Noise Impact Study

642 Dunlop Street W., Barrie

Project No. SP23-01165-00

Reviewer Comments and our Response:

Figure 3-1 Big Blue Bins Facility

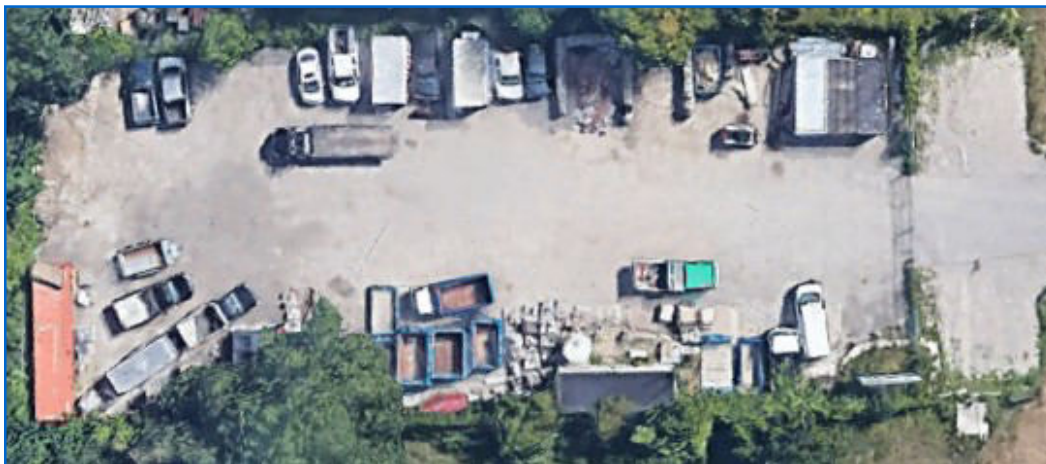
Noise impact from the sources at Big Blue Bins should be included in the Noise Study.

While some noise may arise from the dropping of these bins and related activities, it is important to note that the bins are placed on the ground with care, avoiding any loud impacts to minimize potential damage or dents.

During our site visits, we found no issues related to noise or vibration, leading us to conclude that the noise generated here is negligible compared to other sources.

It is acknowledged that there may be rare instances where bins are inadvertently dropped, resulting in impulsive noise. However, such occurrences are infrequent, lasting only a few seconds, and are exempt from assessment by the Ministry of the Environment, Conservation and Parks (MECP).

Furthermore, given the brief duration of any impulsive noise and the high decibel limits associated with one or two impulses per hour, it is reasonable to conclude that the facility is in substantial compliance with MECP regulations.
